March 9, 2012

FOOD STOREROOM BUILDING RENOVATIONS at ARUBA SURF CLUB

ADDENDUM NO. 3 (Post Bid VE)

1 RISER DIAGRAM - ELECTRICAL
SCALE: N.T.S.

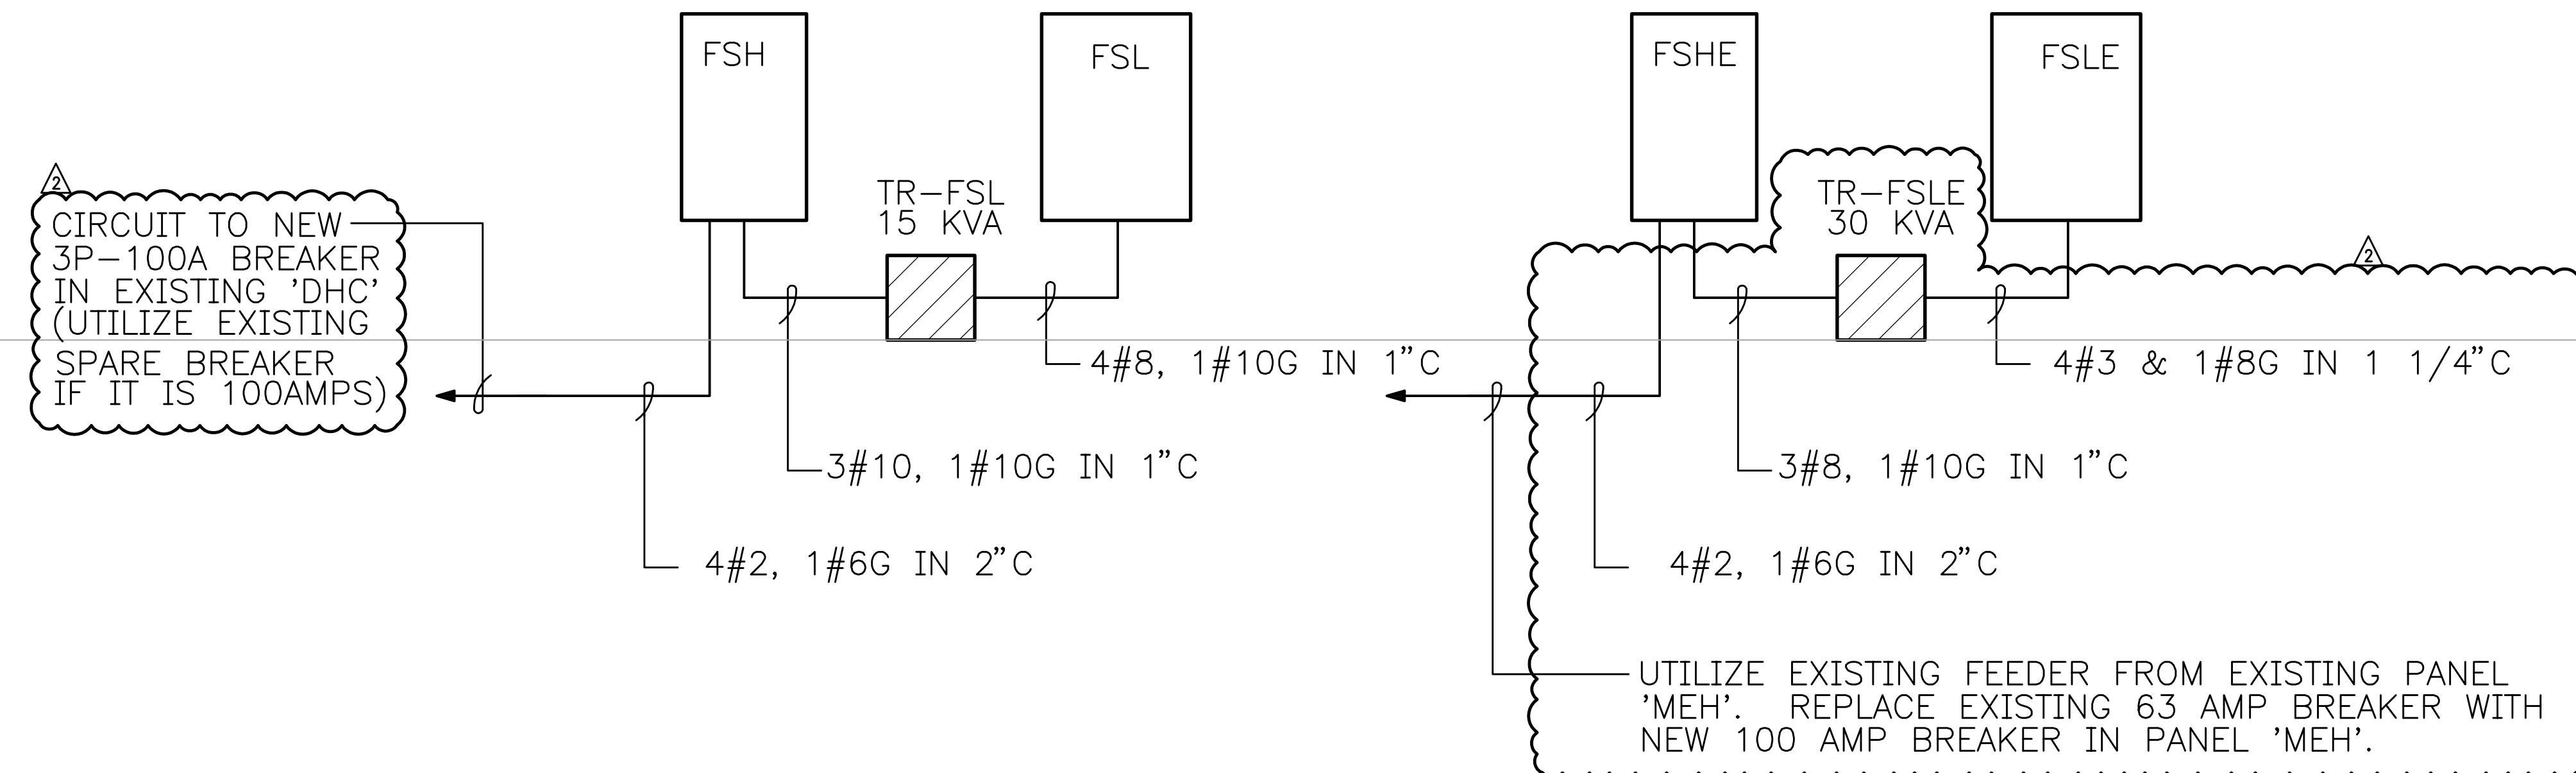
Sheet E4.0 - The following are VE modifications. . See revised E4.0 sheet.

- Wiring Diagram has been modified as indicated on Revised sheet E4.0.
- Modify circuiting as indicated for new air cooled HVAC & refrigeration equipment.
